Re: Appeal of Planning Commission Decision at
Planning Commission Meeting of Monday, August 13th, 7:00 pm
File # 2018-7048 669 - 673 Old San Francisco Road (APNs: 209-17-050 & 051)
Application for Special Development Permit and Vesting Tentative Map to construct a six-unit residential development on the site

I am writing to appeal the decision of the Planning Commission of Monday August 13, 2018, approving the development located at 669-673 Old San Francisco Road, Sunnyvale, CA 94086 (File No. 2018-7048).

Attachment A

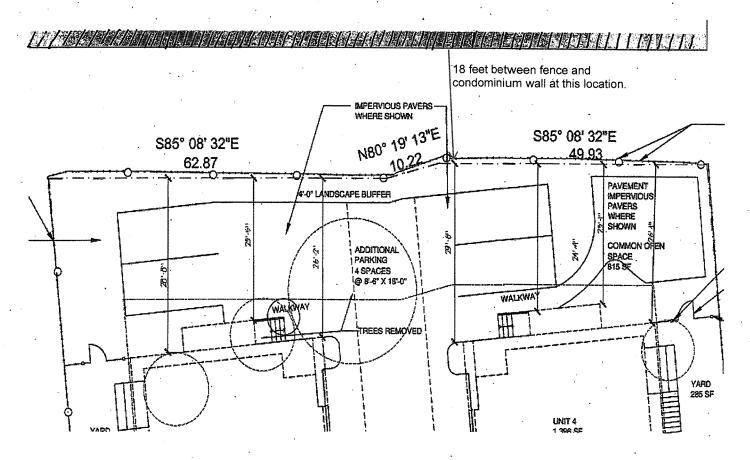
As currently designed, the proposed development continues to maximize unit size and amenities at the sacrifice of thoughtful design that meets Sunnyvale standards as enumerated in the Municipal Code, General Plan, Citywide Design Guidelines and City Design Principles. The inclusion of so many bedrooms and parking spots (16, instead of the required 10) in each unit results in little room remaining on the .34 acresite for setbacks, yards, open space, or the four guest parking spaces required under the municipal code. In an effort to cram all of these elements onto the two lots, one building is moved to within the required front setback, and four guest parking spaces are squeezed within the rear setback along the property line shared with my neighbors (Attachment A hereto).

Parking. Uncovered guest parking remains too close to the living room and bedroom areas of four condominiums (578 Ironwood Terrace units 5, 6, 11 and 12) on the north side of the proposed development. At that location, the landscape buffer is less than 4', contrary to the architectural rendering in Attachment A. Some guest parking would be less than 20' from those units. Additionally, ten of 12 units at 578 Ironwood Terrace would be subjected to the negative impact of exponentially increased daily exposure to carbon emissions, particulate matter and noise from a total of 16 vehicles coming and going from the site due to the proposed location of the driveway and uncovered guest parking. This will impair the existing uses being made by current and future occupants of those residences, affecting their quality of life and quiet enjoyment of the premises.

- Decreasing the size and massing of all units to more appropriately accommodate guest parking, open space and setback requirements:
- Decreasing the size and massing of the units at the back (north) end of the lot, especially the third floors, to reduce shading, privacy, bulk and general nuisance impacts to neighboring residences;
- Relocating the guest parking outside of the rear setback.
